**Louisville - Southern Indiana Ohio River Bridges Project  
Indiana and Kentucky Historic Preservation Advisory Team  
Meeting – November 27, 2007  
TARC Administration Building**

**East End Bridge Presentation: Miguel Rosales, SDC5**

The following shows the average ratings that were provided.

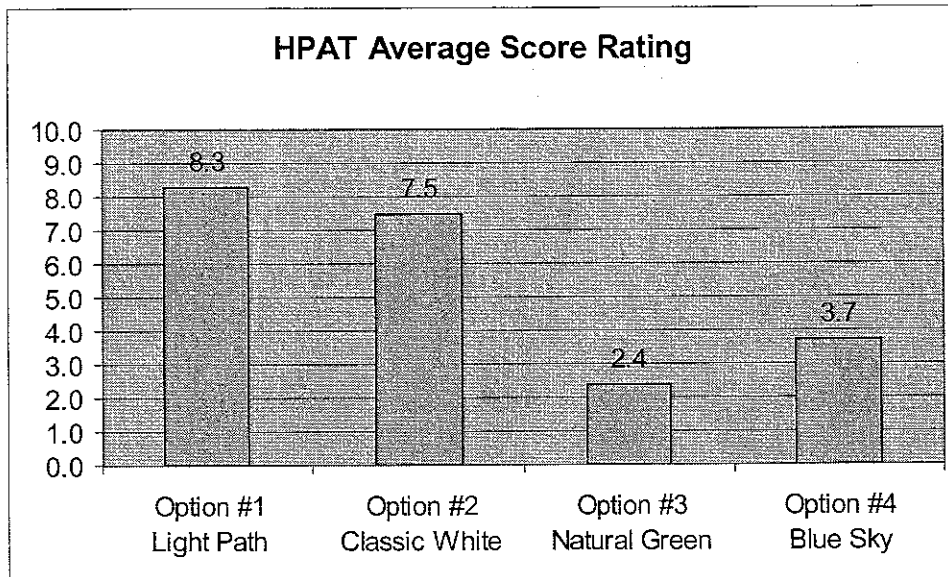
- The comment forms received from the HPAT members indicated an overall preference for Option #1 Light Path, followed closely by Option #2 Classic White.
- The comments indicated that Option #1 Light Path was the most minimal of the concepts, which is desirable in the context of the bridge site. Others indicated that Option #2 Classic White was preferred. Some comments suggested that lighting of the cables, even minimally, emphasized this important part of the design.
- Several HPAT members indicated a preference for the railing lights for the walkway, in order to minimize the spill of light off of the bridge.
- Others indicated that the underneath side of the walkway should not be lit, in order to maintain as much darkness in the area as possible.
